RESOLUTION 2013-77

A RESOLUTION TO APPROVE THE MODIFIED CONSTRUCTION SCOPE FOR THE 3RD AVENUE NORTH TRAIL/GREENWAY PROJECT

SUBJECT: **Funding Discussion for the 3rd Avenue North Trail/Greenway Project (Bicentennial Park Phase II) (COF Design Contract No. 2012-0069)**

SUBJECT: **Consideration of Resolution 2013-77, A Resolution To Approve the Modified Construction Scope for the 3rd Avenue North Trail/Greenway Project.**

Exhibit B
Page 1 of 2
Overlook at Harpeth River

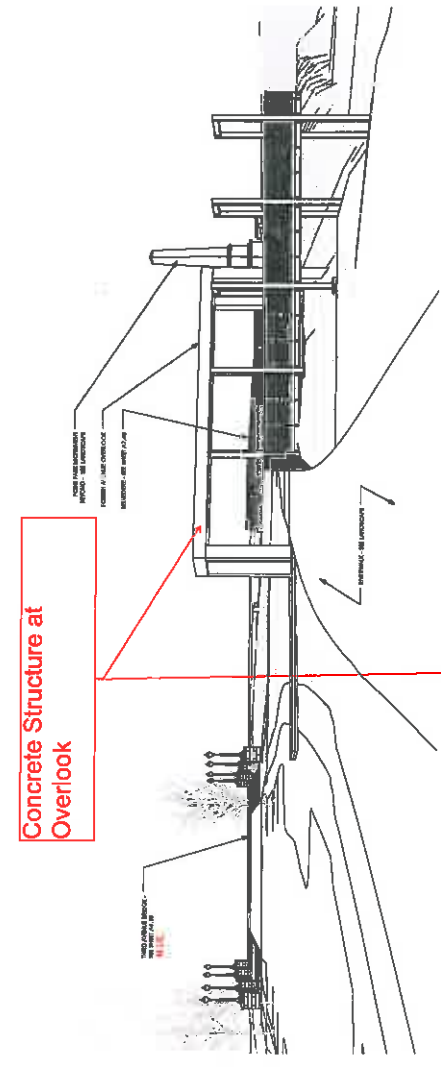
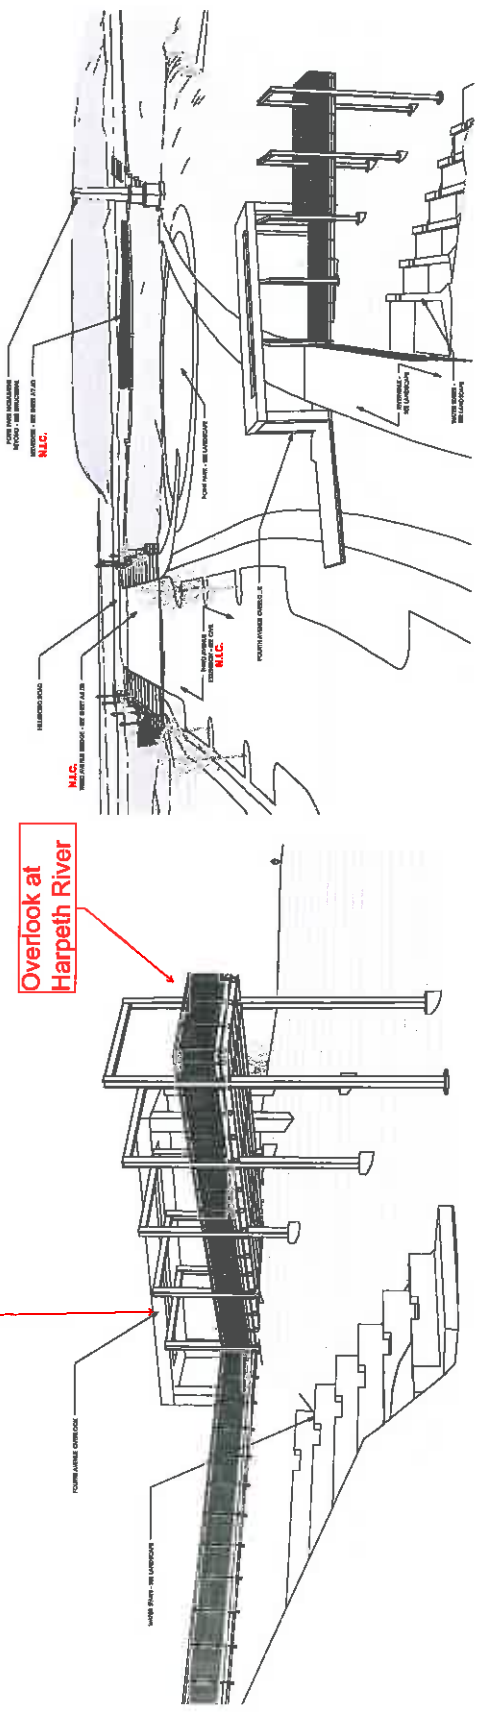
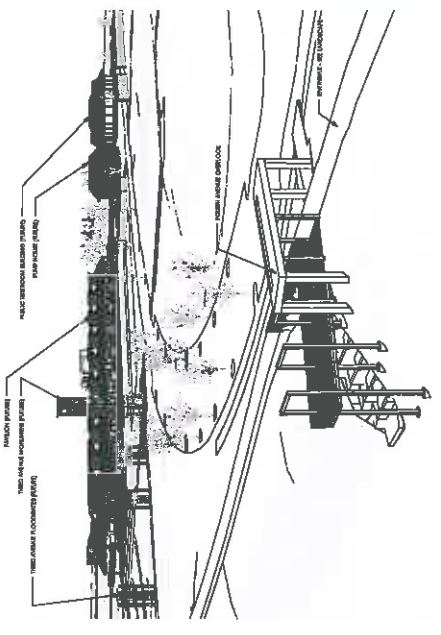
Option #2 – Eliminate the Concrete Structure at Overlook (Exhibit B) and the Obelisk at Point Park (Exhibit C). Other items to reduce costs would include changing from stone cut park benches to ornamental steel benches, use cheaper Overlook Railing, change from stone pavers at Obelisk to concrete or sod, and other small reductions. See Exhibit A for a detailed breakdown for possible savings. Small revisions to plans are required. Project cost estimate is around \$1,100,000.00 (\$630,000 Federal / \$470,000 City).

At the CIC meeting, Staff was directed to eliminate the architectural concrete structure at the overlook (\$91,000) and the stone obelisk/monument at Point Park (\$139,000). This results in a cost savings of \$230,000 for the project.

SECTION II: BE IT FURTHER ORDAINED by the Board of Mayor and Aldermen of the City of Franklin, Tennessee, that the following items be eliminated from the current 3rd Avenue North Trial/Greenway Project Scope: the architectural concrete structure at the overlook, obelisk/monument at Point Park, stone pavers at Point Park and one-half the boulders along the top of bank.

Exhibit B
 Page 2 of 2
 Overlook at Harpeth River

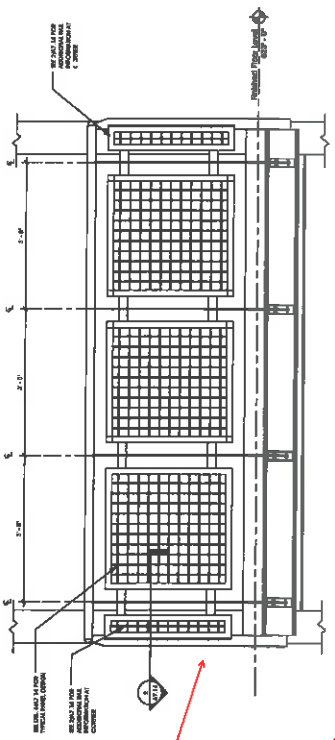
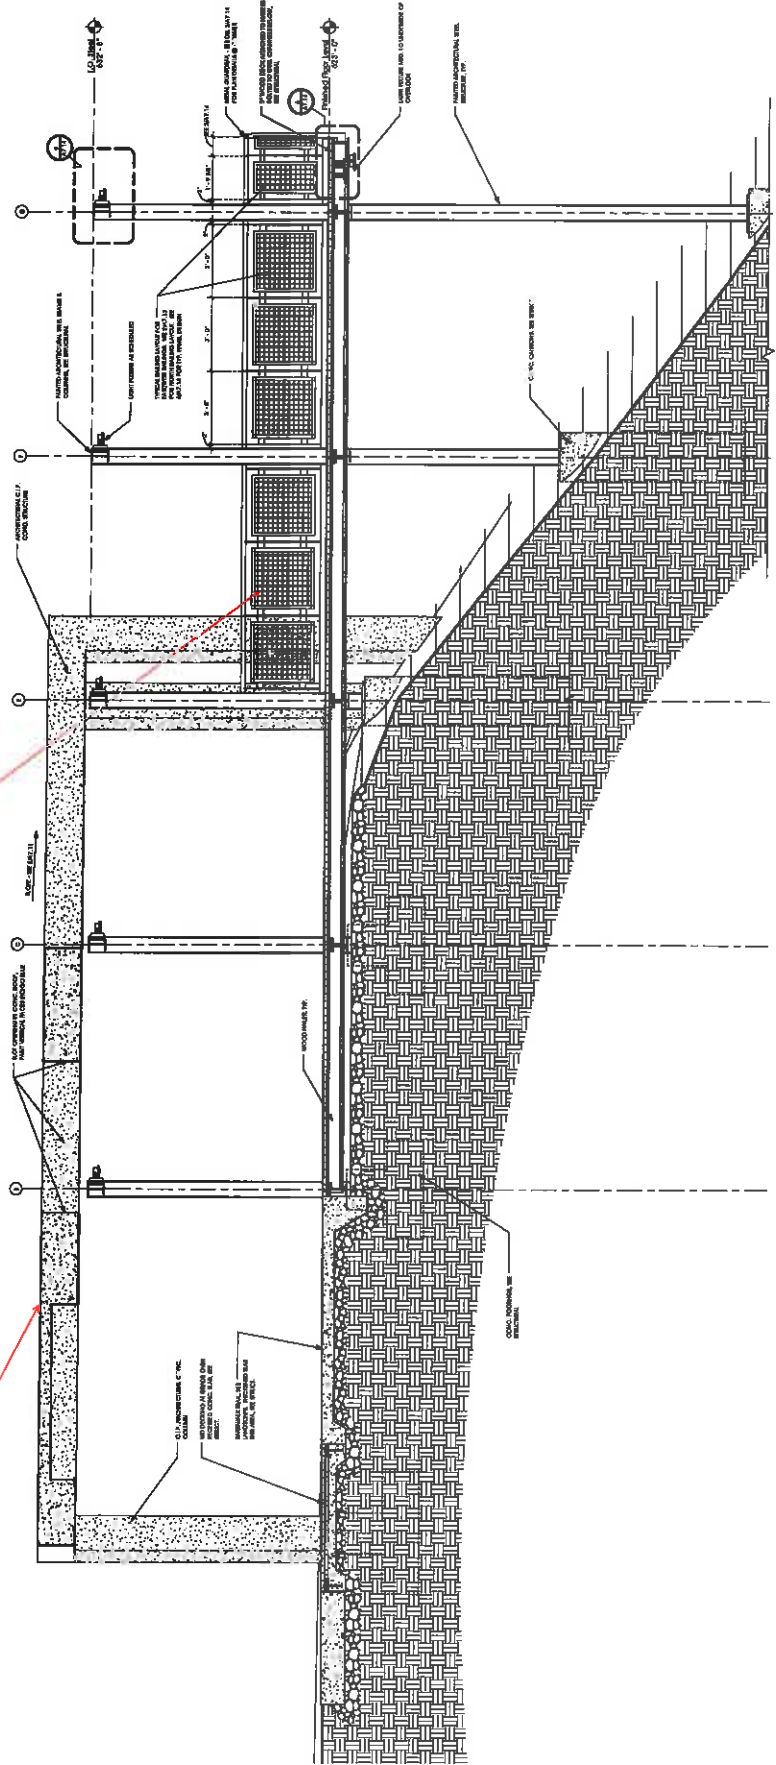
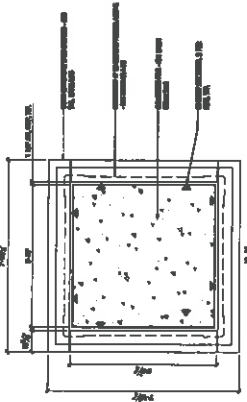
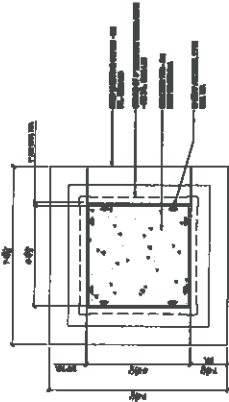
Decorative Railing
 at Overlook

- Keep the decorative railing at the overlook. The decorative railing will match the bridge rails currently being installed on the 3rd Ave N Bridge. Changing to a cheaper mesh frame rail could result in a \$69,000 savings.
- Keep the brick circular walking trail at Point Park. The circular brick walking trail will match the brick sidewalks currently being installed on the roadway project. Changing to a concrete trail could result in a \$49,000 savings.
- Keep the cut stone benches. The stone cut benches match the stacked stone walls around Rest Haven Cemetery.
- Eliminate the Stone Pavers at Point Park. This will realize a \$54,000 savings and can be installed in the future.

Exhibit C
Page 2 of 2
Obelisk at Point Park

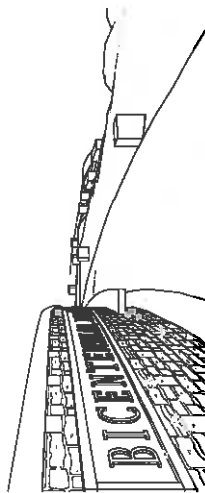
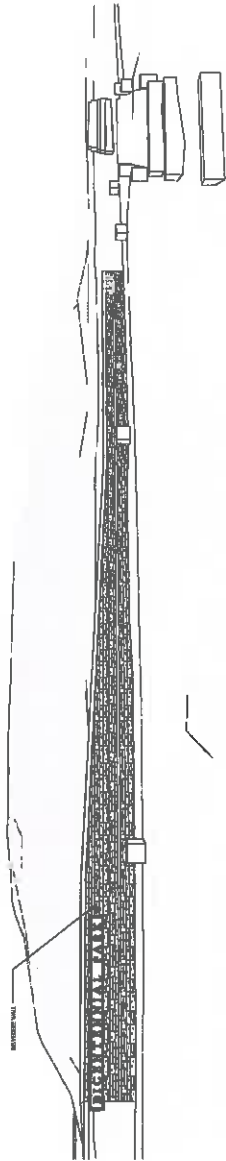
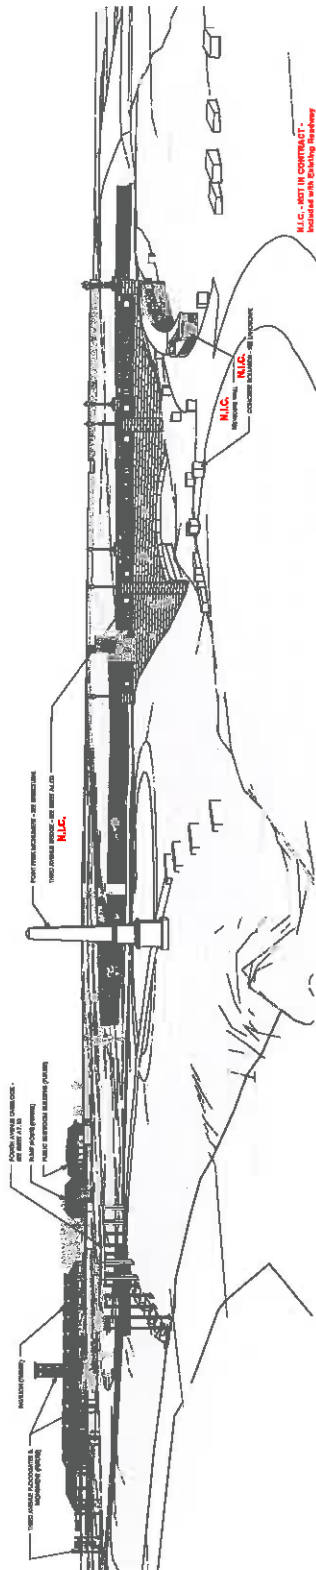
Option #3 – Include all cost savings from Option 2, as well as eliminate Point Park (Exhibit C, Page 2). This will realize another \$140,000 cost reduction. Plans will need revisions, and State permits will need to be resubmitted. Project cost estimate is around \$950,000.00 (\$630,000 Federal / 320,000 City).
